STATE OF NORTH CAROLINA  
DEPARTMENT OF TRANSPORTATION

Subject: **Application for Modification to Section 404 and Section 401 permits and Neuse Buffer Certificate for the Knightdale Bypass**--US 64 from I-440 (Raleigh Beltline) to existing US 64 near SR 1003, I-440 from 0.83 mile south of US 64 to Poole Road and a portion of the East Wake Expressway from existing US 64 to the proposed US 64 Bypass in Wake County. State Project No. 8.142202, Federal Aid Project No. NHF-DPI-0199 (004), TIP No. R-2547 BA and CC, \$475.00 Debit Work Order 8.142202, WBS Element 34455.1.7. NCDENR-DWQ Water Quality Certification Project No. 011689 and USACE Action ID 200220819.

The purpose of this submittal is to request a modification to the Section 404 Individual Permit, Section 401 Water Quality Certificate and the Neuse Buffer Certification, specifically for Sections BA and CC. The modification for the permit is for changes to the horizontal alignment of a ramp at Site 4 and additional buffer impacts at Site 3 and 19.

N. C. DEPT. OF TRANSPORTATION  
 DIVISION OF HIGHWAYS  
 WAKE COUNTY  
 PROJECT: 8.1402202 (R-2547BA)  
 US 64 BYPASS FROM I-440  
 TO NEW HOPE ROAD  
 SHEET 7 OF 25 9/15/2004  
 Rev.

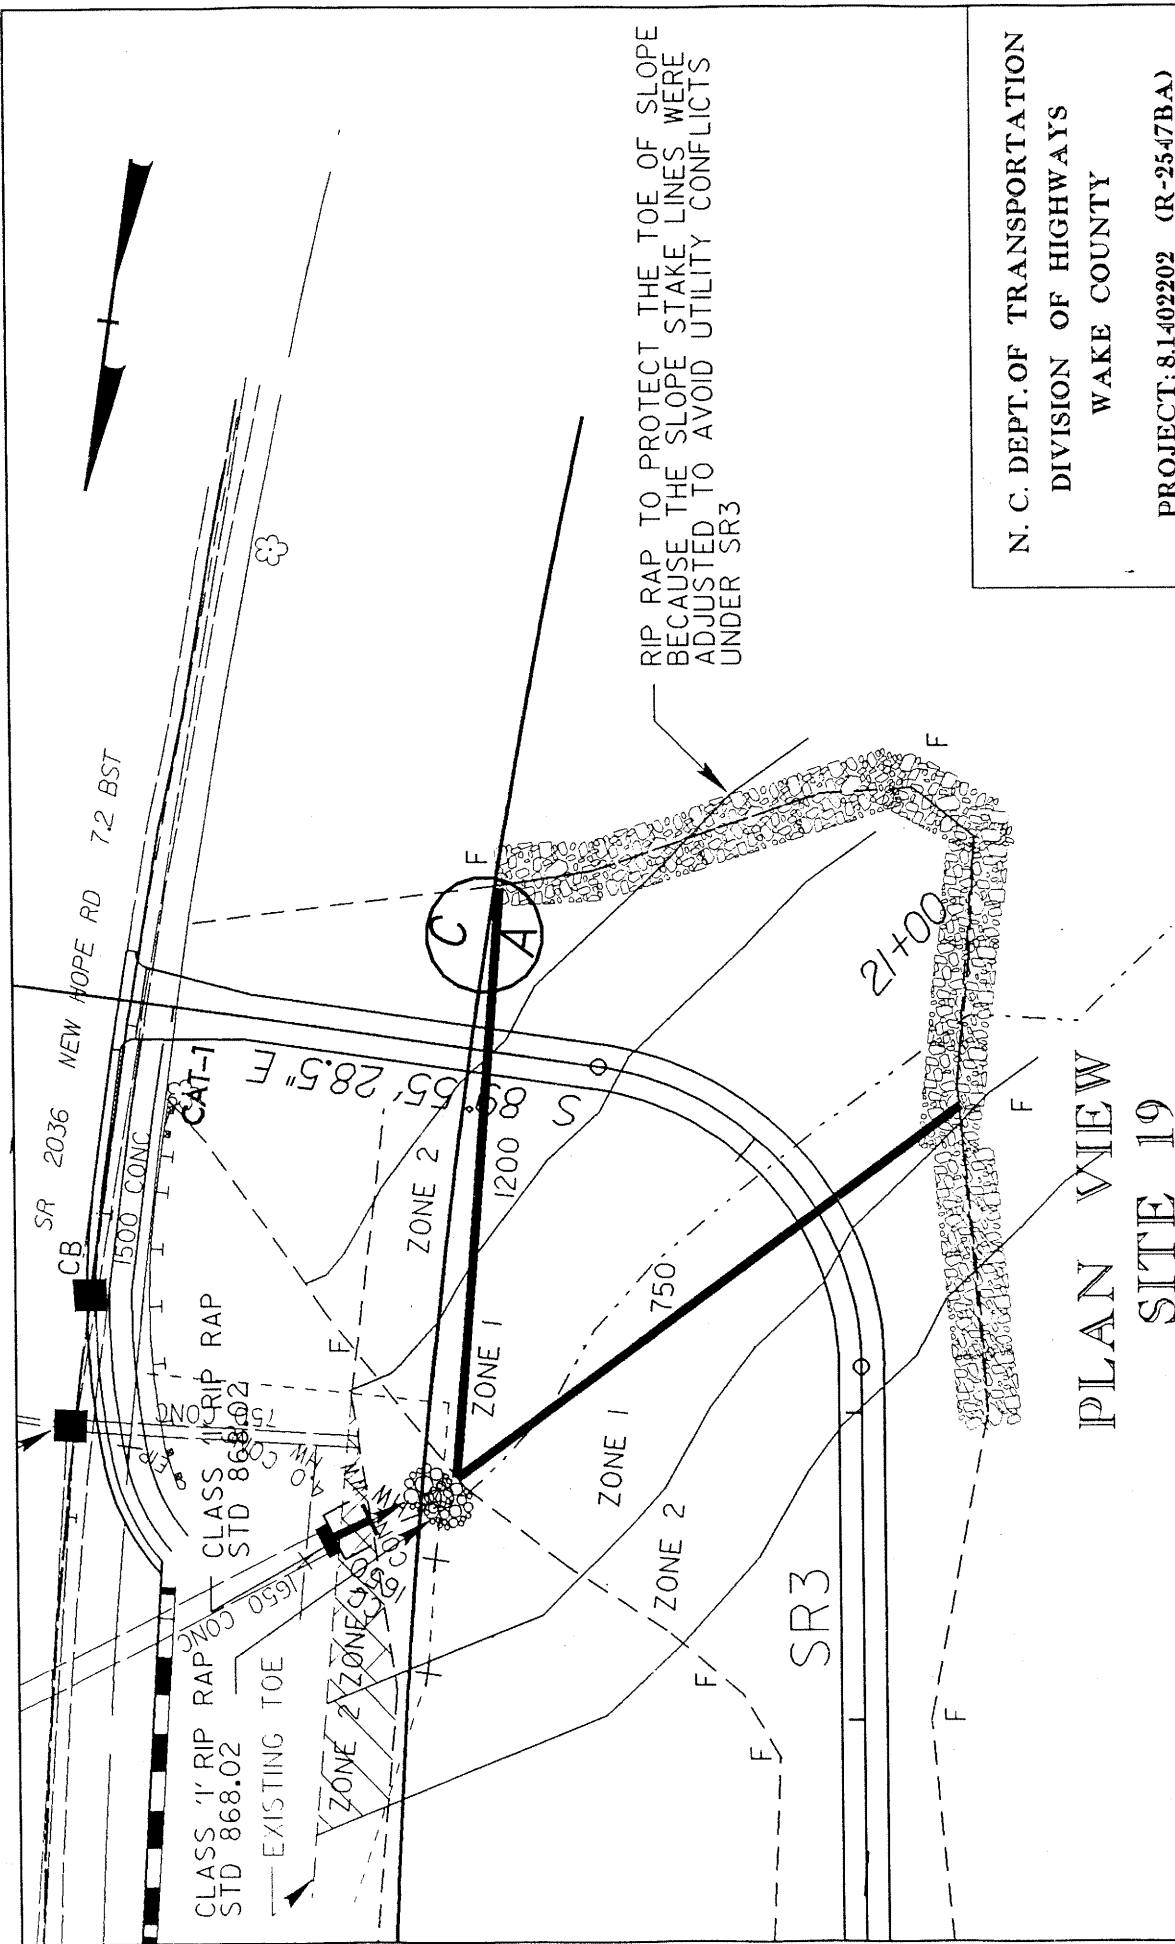
#### Permit Drawing 7 of 25/Site 4

**Issue:** The current design of the ramp at Site 4 will not provide a smooth approach to the newly constructed bridges.

**Status:** The original plan for the ramp has begun construction

**Impact Analysis:** No changes in impacts will occur to jurisdictional areas or buffers

**Resolution:** The New Hope Road (-Y1-) horizontal alignment was revised from -Y1REV- Sta. 15+45.467 to 17+32.782 in order to provide a smoother approach to the bridges that have already been constructed. The bridges and the bridge sketch were revised to reflect what has been constructed.

PLAN VIEW  
SITE 19

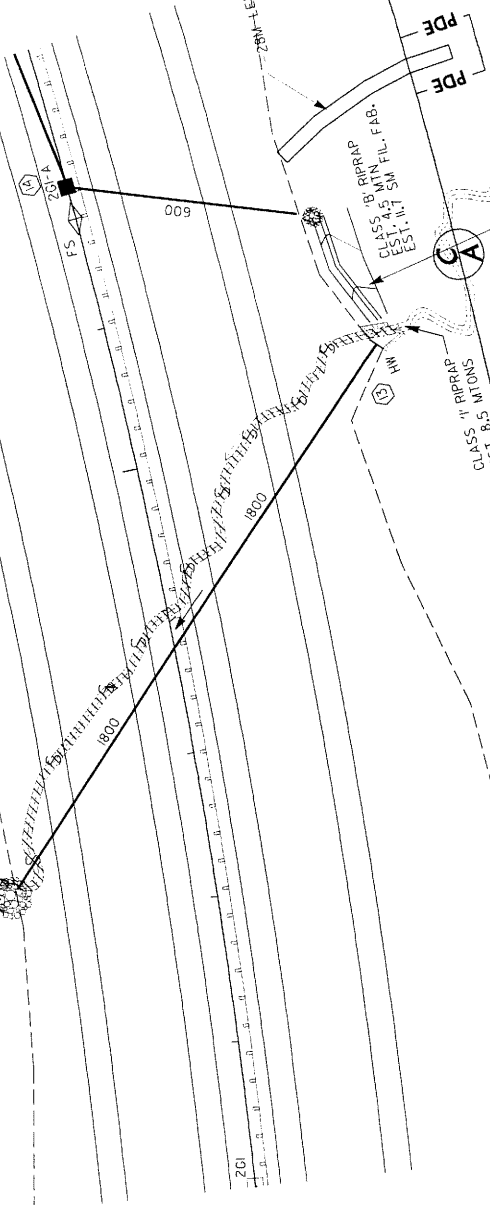
#### Permit Drawing 21 of 25/Site 19

**Issue:** The property owner at this site wanted to put in a driveway for access to the property.

**Status:** Not yet constructed

**Impact Analysis:** Impacts by the above revisions will be to an additional 10ft of jurisdictional stream and additional buffer impacts of 481 sq ft in Zone 1 and 414 sq ft in Zone 2.

**Resolution:** A partial driveway turnout located across from the ramp/loop termini in quadrant D of the New Hope Road interchange was added. This occurs at approximate station No. -Y1rec- Sta. 17+32.782. The pipe will be extended for the driveway and an additional right-turn and left-turn lane will be provided on New Hope Road to provide access to the driveway. The remainder of the driveway will be constructed by others at a later time. The control of access fence will not be removed at this time.

U. C. DEPT. OF TRANSPORTATION  
DIVISION OF HIGHWAYS  
WAKE COUNTY  
PROJECT: 8.1-02202 (R-254700)  
US64 FROM SR2502 TO EXISTING  
US64 JUMP SR1005  
SHEET 6 OF 24 REV 8/30/04

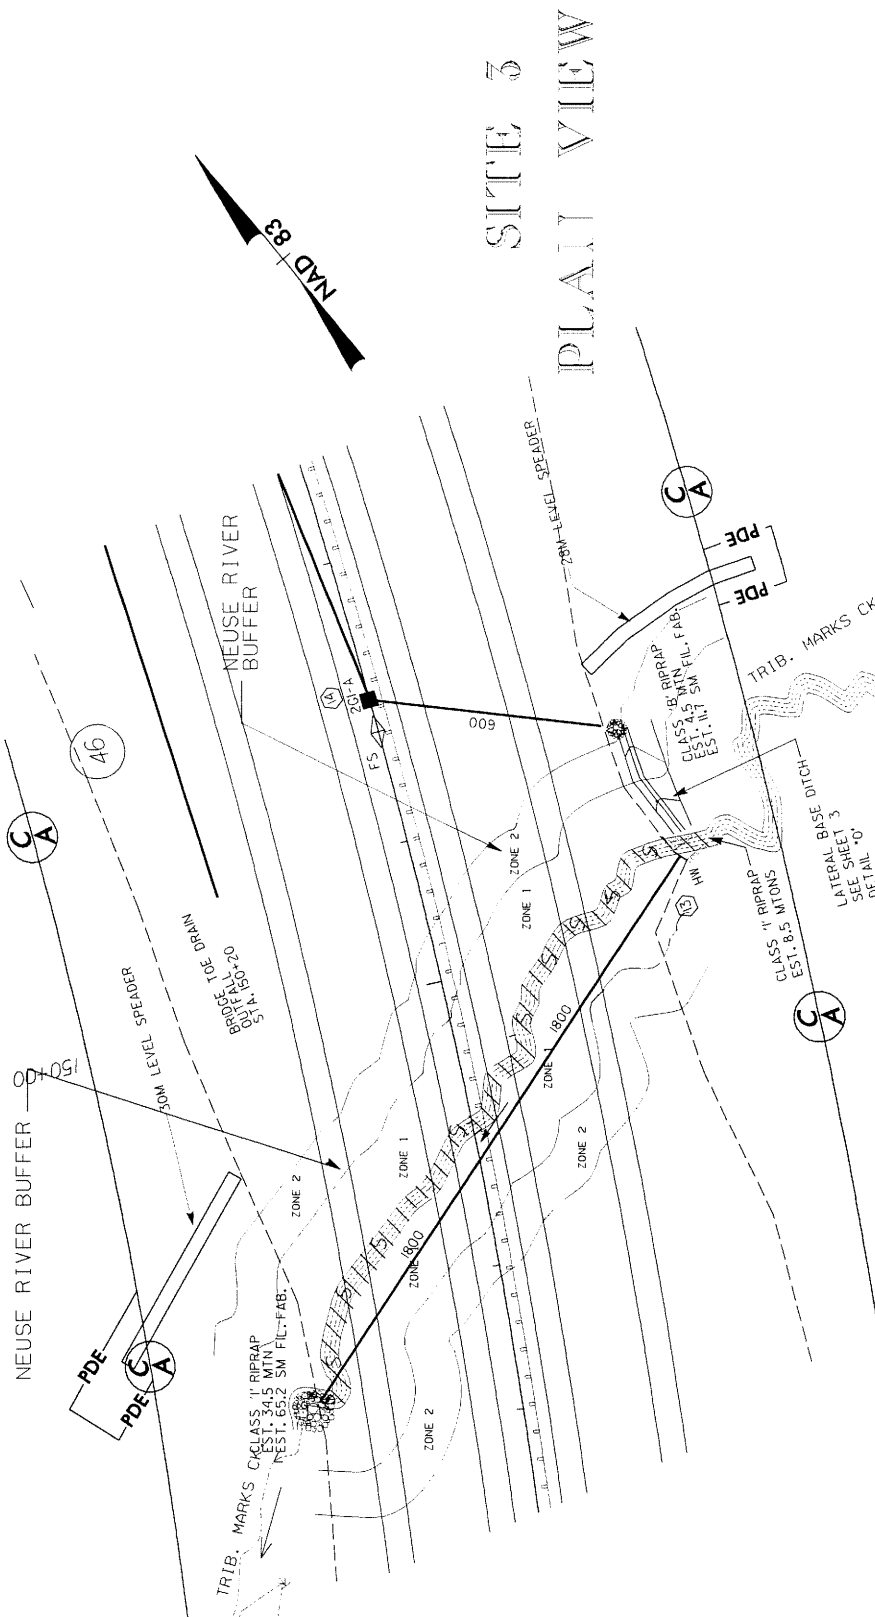
Site 3 Section CC (Current Permit Drawings 6 and 7 of 24 dated 12/11/03, Proposed Revised Permit Drawings 6 and 7 of 24 dated 8/30/04 and Revised Permit Drawing 23 of 24 dated 8/30/04) and Construction Plan Sheet 6

**Issue:** Current permit drawings 6 and 7 of 24 depict a preformed scour hole at the outlet of a 600 mm pipe. The proposed revised permit drawings 6 and 7 of 24 depict a grass-lined swale at the outlet of the 600mm pipe right of station 150+30 –L-.

**Status:** The grass-lined swale has not been constructed.

**Impact Analysis:** Construction of the grass-lined swale will impact 204 square feet of riparian buffer in Zone 1 and 280 square feet of riparian buffer in Zone 2.

**Resolution:** A 600mm pipe enters the narrow side of Structure #14 in the roadway median, therefore a Type 'A' box is required and a minimum depth box cannot be used. The median ditch elevation (Structure #14 Rim) is 72.50 with the invert of Structure #14 at 71.05. The natural ground at the 600mm pipe outlet (located outside of the 50 foot buffer) is approximately elevation 72.50. The 600mm pipe invert at this location is 70.80. Due to the elevation difference, the preformed scour hole would require excavating approximately 1.5 meters (5 feet) at the pipe outlet and would not function correctly. The preformed scour hole would back water up into the storm drainage system and median ditch, which is a safety hazard and not standard practice. Directing the pipe outlet to the other side of the roadway would still require a ditch through the buffer, since the natural ground elevation outside the buffer zone is approximately 72.1.

The grass-lined swale at the outlet of the pipe is needed to provide positive drainage and to prevent storm water from backing up into the drainage system. Treatment of storm water is provided by grass-lined swales. A summary of the treatment calculations for each drainage inlet has been included to show that treatment has been provided. The same drainage area and quantity of impervious area is directed to the outlet as in the previous design and the revised design allows the site to remain in compliance with the riparian buffer rules.
